Date: 20 May 2021
Your Ref: NYM/2020/1018/FL
Our Ref: 006/2020/02

PROPOSED REVISIONS: Full/detailed planning for a 150 space visitor car park, vehicular bridge, and other ancillary infrastructure (pay stations, electric vehicle charging points, CCTV poles and cycle stands/storage) and a small section of pedestrian route/footpath on 0.59 hectares (1.47 acres) of land on the former timber yard, East Row, Sandsend (Planning Application Ref: NYM/2020/1018/FL)

Report title:	Designers Response to Stage 1 RSA
Date:	May 2021
Document reference and revision:	11613-004-01
Prepared by:	Sanderson Associates (Consulting Engineers) Ltd
On behalf of:	The Mulgrave Estate

Drawing 11613-006

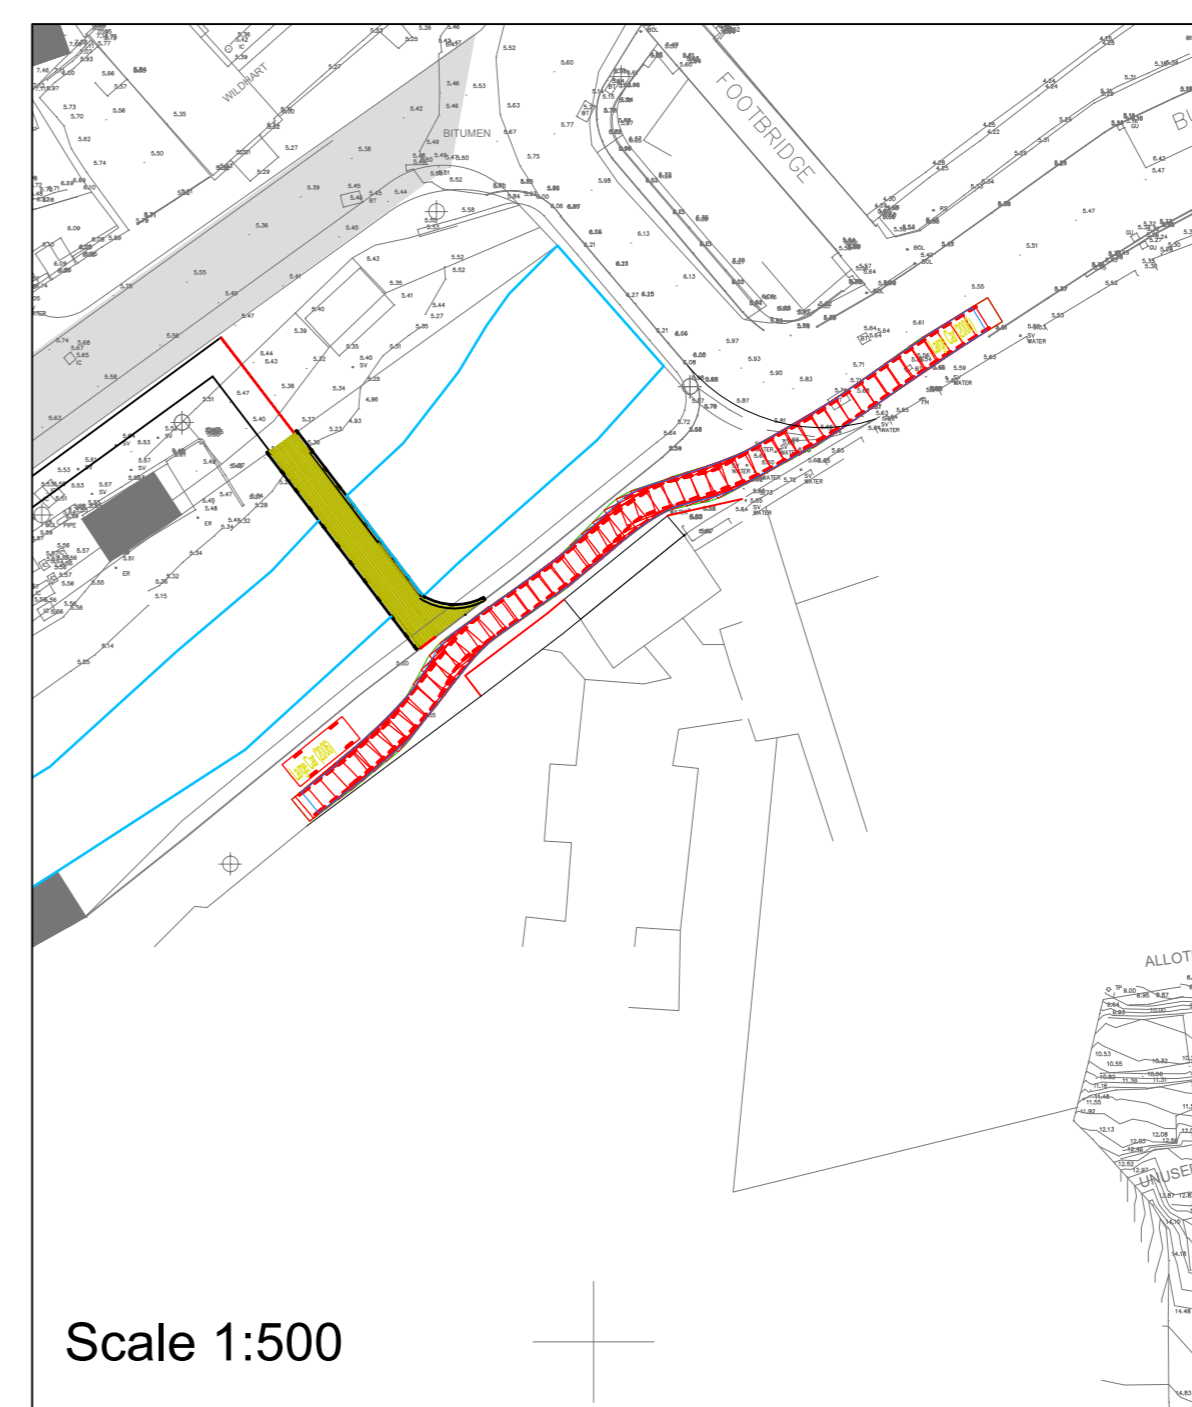
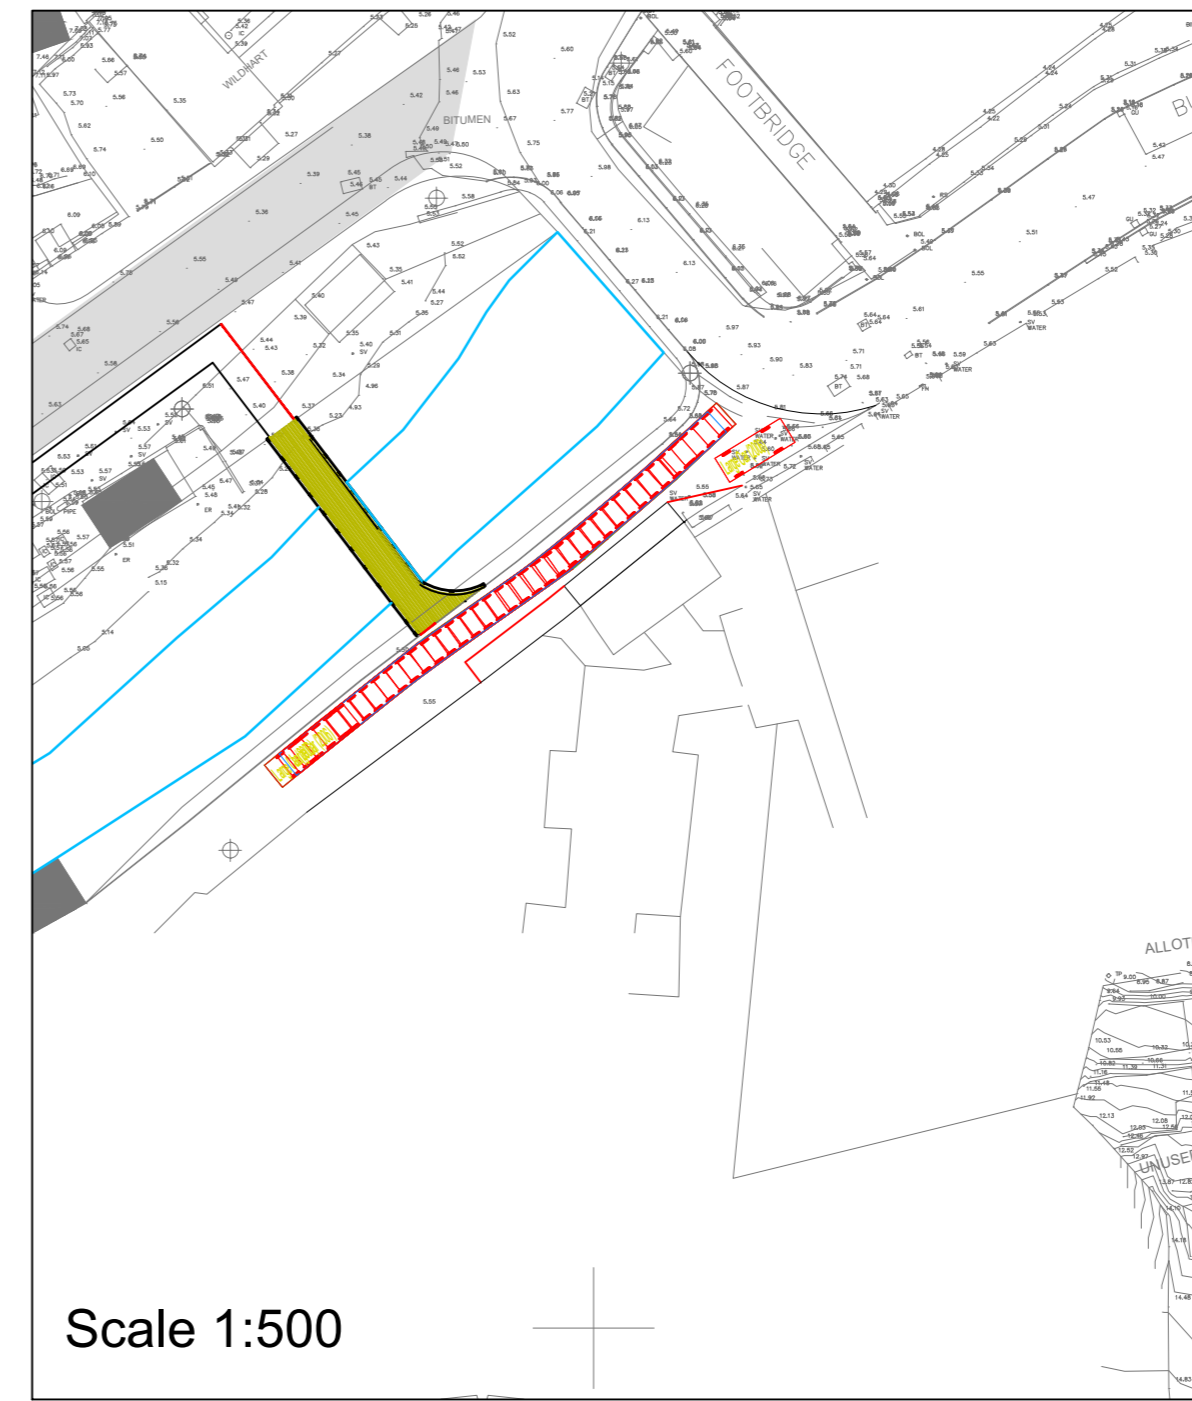
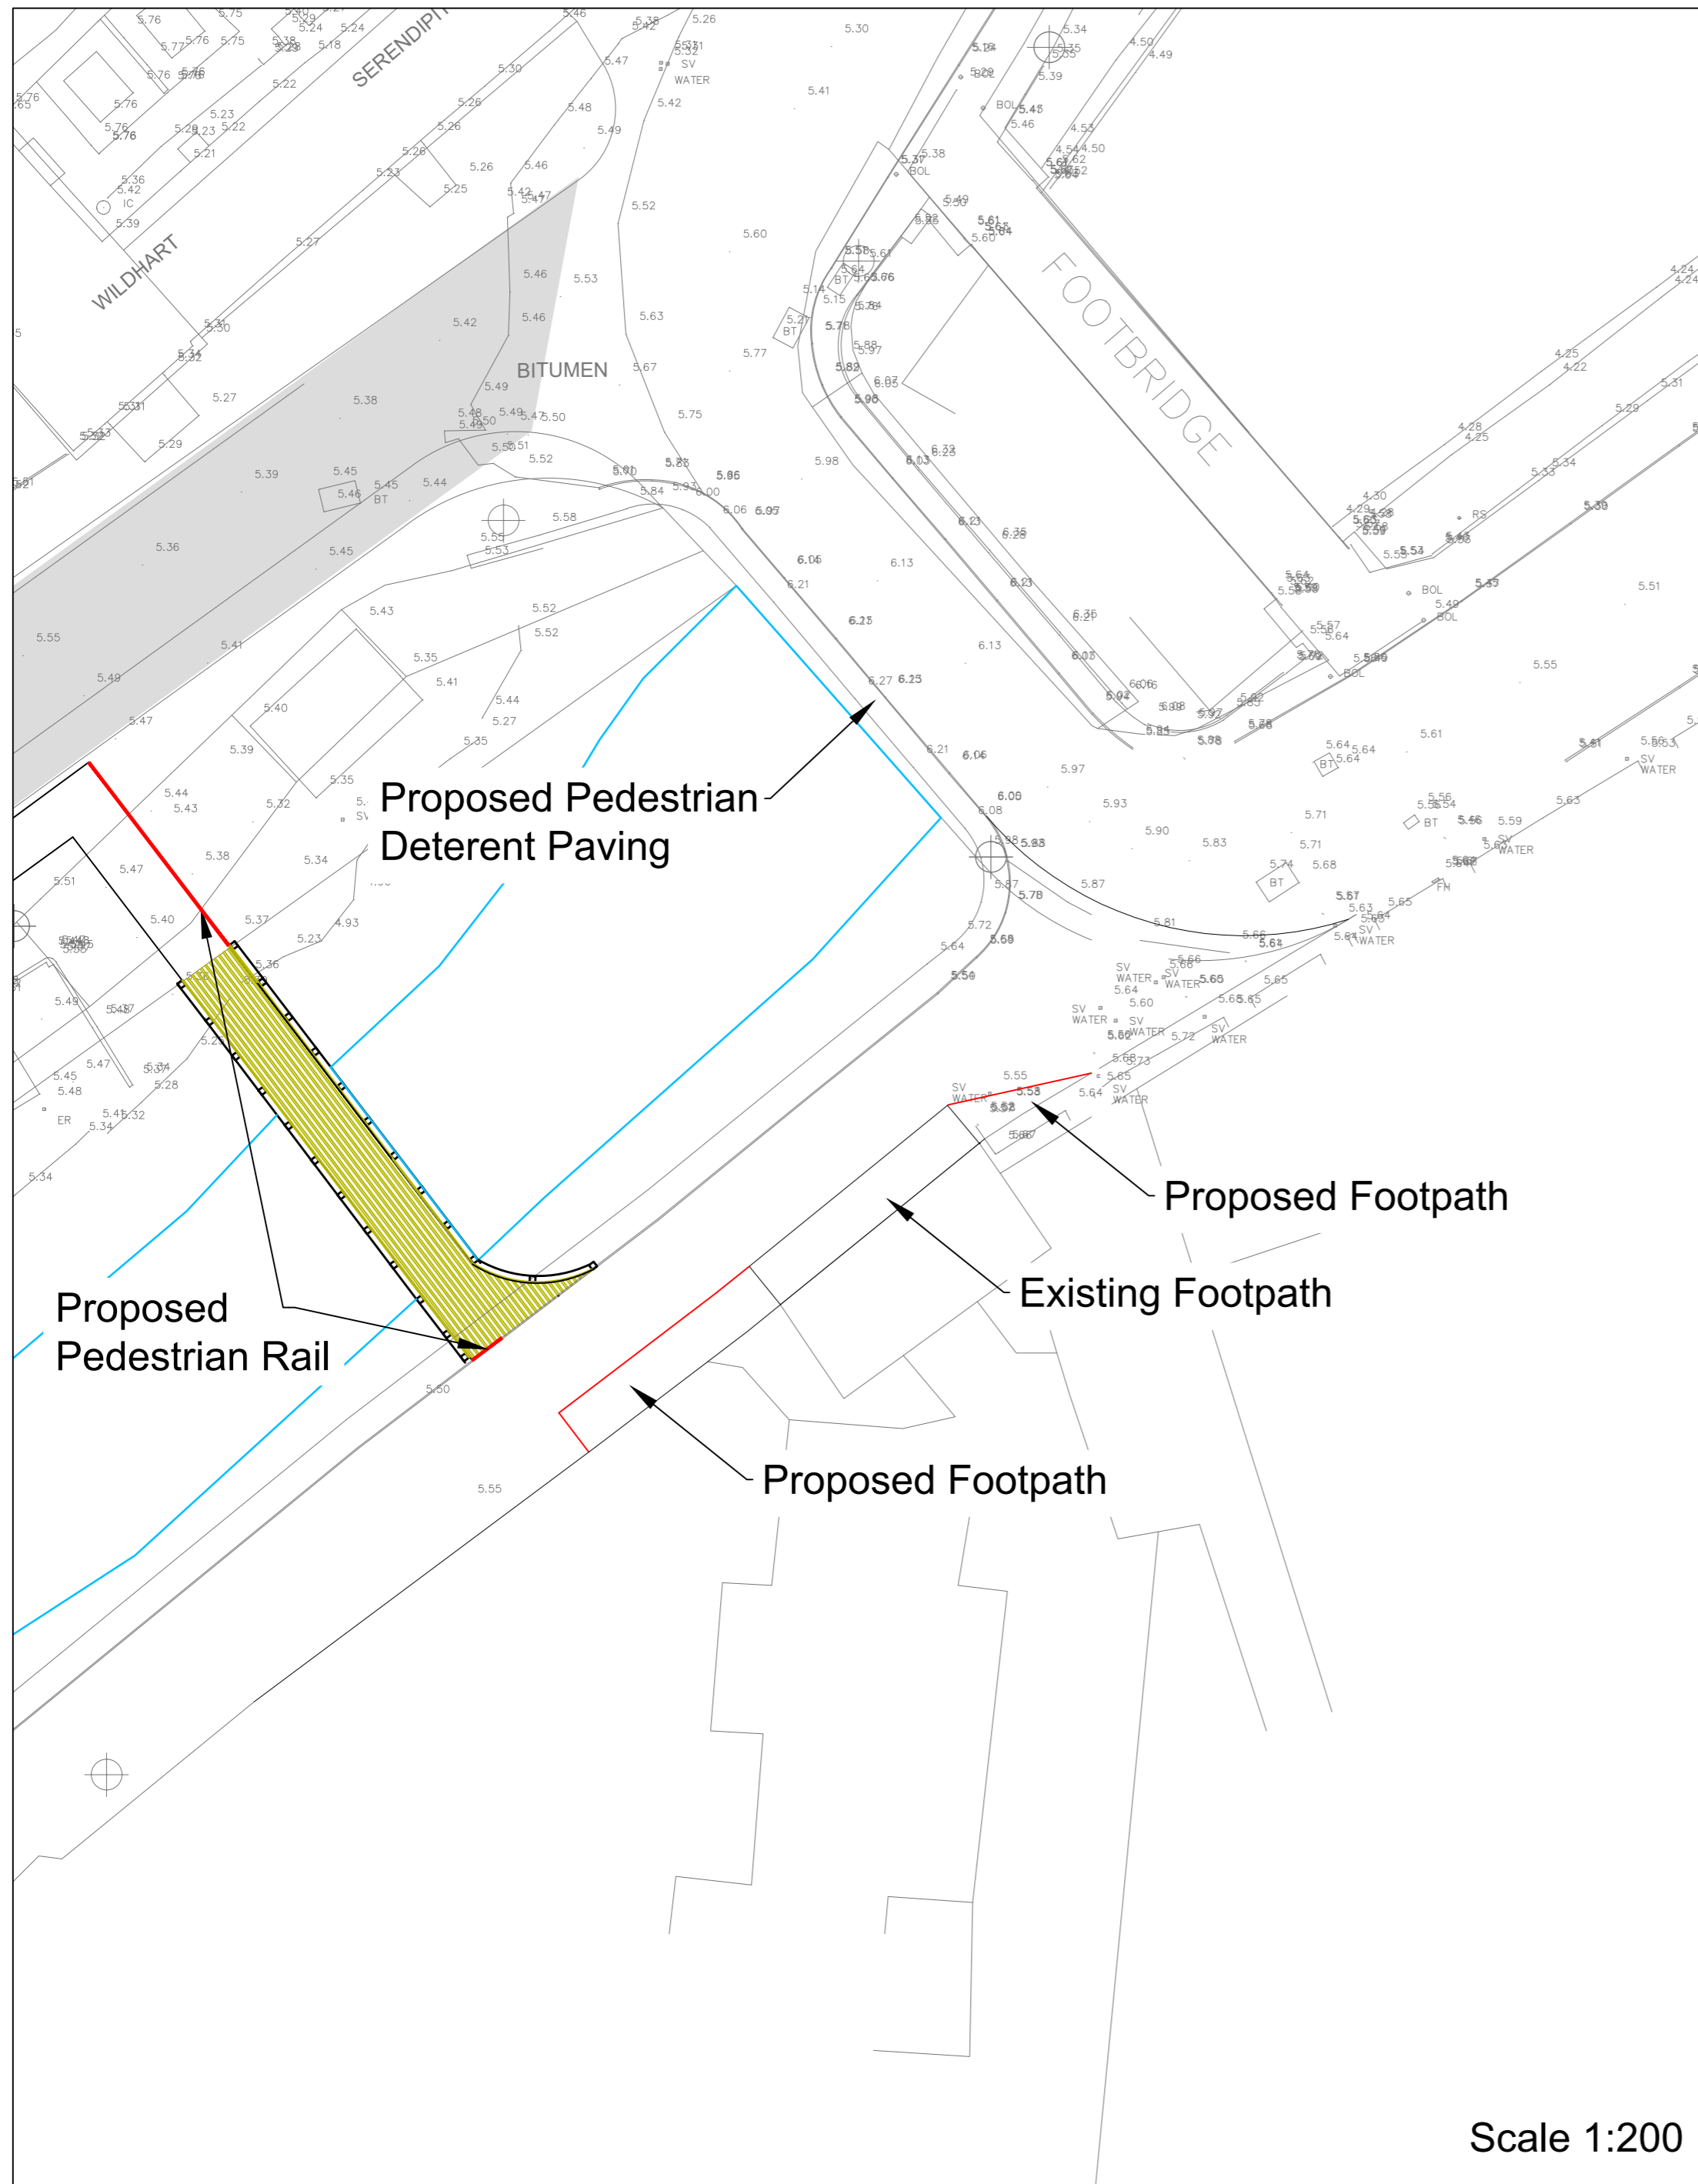
Summary: Drawing 11613-004 indicates that there is no pedestrian route on to the A174 and that the pedestrian access to / from the car park to the A174 is along the existing footpath / private drive. It is understood that this relates to vehicle occupants accessing the car parking where the existing footpath should be used to minimise foot traffic across East Row Bridge. The existing footpath / private drive is in very poor condition in terms of its surfacing and drainage for access on foot and there is no indication of whether improvements are proposed. It is also used for vehicular access to the properties along the private drive. The existing footpath route in its present condition would not be attractive for use by people with pushchairs / wheelchairs, young children and those with mobility / visual impairments and vehicle occupants would likely be attracted to use the new access road since there is a footpath along part of it (between the two proposed bridges) and it is then only a short distance (circa 110m) to the A174 where there are the existing shops and Fish Cottage. Pedestrians using the new access road in this manner could lead to pedestrian / vehicle conflict if they walk in the carriageway to gain access to the A174.

Summary: Drawings 11613-003 & 004 do not show if any pedestrian improvements are proposed at the junction of the existing footpath / private drive with the A174. There are existing part time (21 March to 30 September) waiting restrictions on the adopted part of the A174 junction area and a car was observed parking on the private drive part against the existing footway, effectively blocking access to the footway from the private drive. Furthermore, there are no existing dropped kerbs (or tactile paving) or a clear route to indicate how pedestrians should join the existing footway from the end of the private drive. Inadequate pedestrian facilities could lead to conflict between pedestrians and vehicles in the private drive junction area and where vehicles are also negotiating the sharp bend on to the East Row Bridge.

Summary: Drawing 11613-004 does not clearly show the proposed pedestrian facilities and dimensions where the pedestrian access route joins the access road just to the south of the vehicle access bridge or across the bridge. Inadequate pedestrian facilities and width could lead to conflict between pedestrians and vehicles where pedestrians need to cross the access road or walk along it to access the car parking area.

Designers Response: *An alternative pedestrian access strategy has been developed which does not involve pedestrian movements along the unmade sections of the private road. Pedestrians will utilise a proposed footbridge located ~45m south-west of the A174 East Row Bridge to cross between the vehicle access road to the north of the beck and the private road to the south of the beck. A suitably surfaced, delineated footway is proposed along the southern side of the private road between the footbridge and existing pedestrian infrastructure along the A174. The proposed pedestrian improvements are shown on drawing 11613-006 at **Appendix B**.*

Designers Response: *A suitably surfaced, delineated footway is proposed along the southern side of the private road from the footbridge and will tie in directly with the existing pedestrian infrastructure along the A174. This is shown on drawing 11613-006 at Appendix B.*

Designers Response:- *A continuous 2.0m wide pedestrian footway is proposed from the car park, along the access road to the proposed pedestrian footbridge located ~45m to the south-west of East Row Bridge. The footway will include 1.0m high bird-mouth fencing along the top of embankment to prevent falling from height and a 0.45m high chain-link fence will be provided along the edge of footway / edge of carriageway.*
